### New IMP Series Regulator

**IMP53-50981-001**

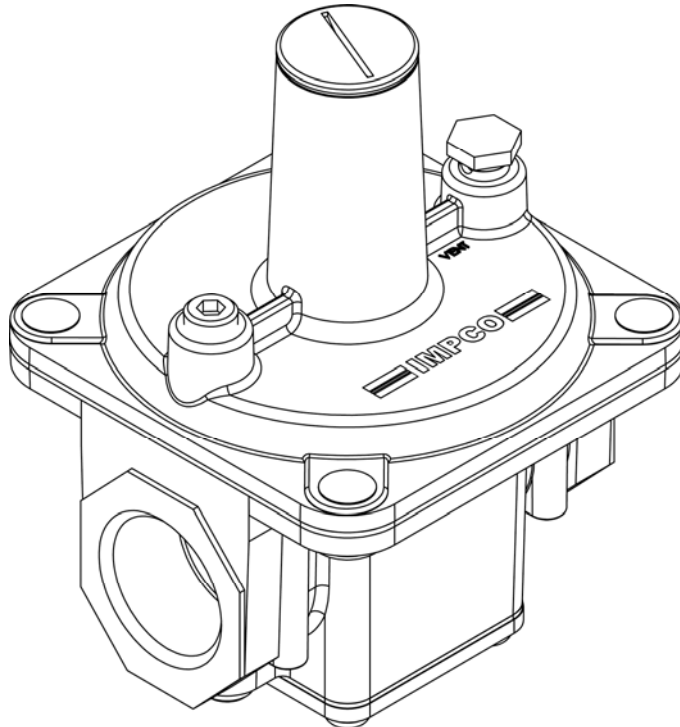
This TSB introduces part number IMP53-50981-001, an improved version and direct replacement for the current IMP53 series low pressure regulator. The IMP53-50981-001 is manufactured by IMPCO Technologies, Inc. and is UL recognized. Product enhancements include: 1/8" NPT diagnostic test ports on the inlet and outlet, an additional vent port, tamper resistance capability (with the installation of optional pressure adjustment plug, part number P3-17956-18), and a new satin aluminum finish. Part number IMP53 will no longer be available and is permanently replaced by part number IMP53-50981-001.
